2015/6455/P Planning Application Comment

Discrepancies in Reported Sunlight to Gardens

Save West Hampstead “Stop the Blocks!” Campaign

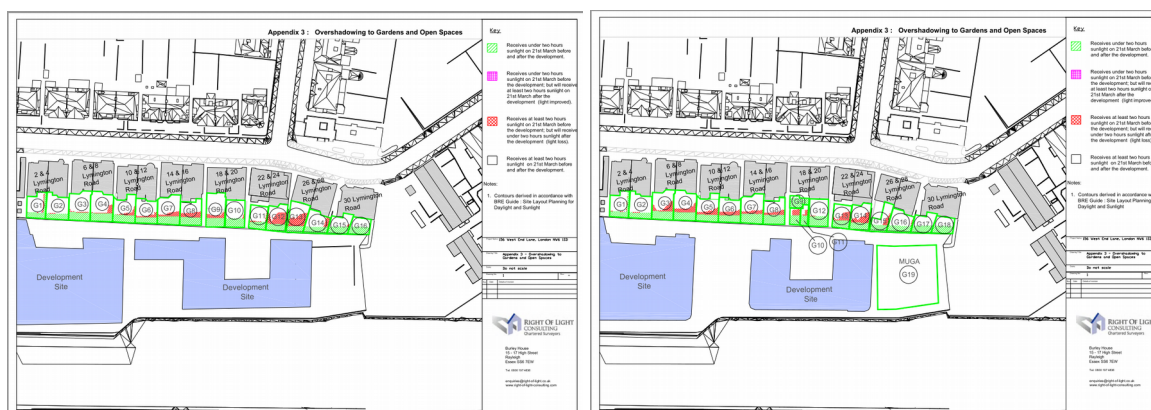
14. The image above has been created by overlaying two images from the 'existing' shadow analysis for 21st March (12pm and 2pm) as contained in the June Daylight and Sunlight report, Appendix 4 Overshadowing Images of Amenity Areas.

15. The resulting image has been further overlaid by the Appendix 3 Overshadowing to Gardens and Open Spaces diagram from the same Revised Daylight and Sunlight Report (Neighbouring Properties) report.

16. The final composite image above shows that the Green shaded area, identified in the Key as "Receives under two hours sunlight on 21st March before and after the development", is far larger than the actual existing area (shown in black beneath the hatching) if the Appendix 4 overshadowing images are correct. The black shading beneath the hatching results from the small amount of overshadowing of gardens from 7ft high back garden walls.

17. Therefore the Appendix 3 diagram is not only incorrect but also grossly misleading. For example, gardens G7 and G8 appear to receive almost no sunlight across approximately 50% of the garden area for two hours in March. Whereas by overlaying the Appendix 4 images, approximately 80% of both gardens receive in excess of four hours sunlight as a minimum, on 21st March before the development.

18. Furthermore, the diagram of the Development Site shown in Appendix 3 of the Revised Daylight and Sunlight Report (Neighbouring Properties) June report is misleading insofar as it is not a complete representation of the proposed development and a substantial section has

been removed. This gives the appearance of an open space in between the West and East buildings which is not the case.
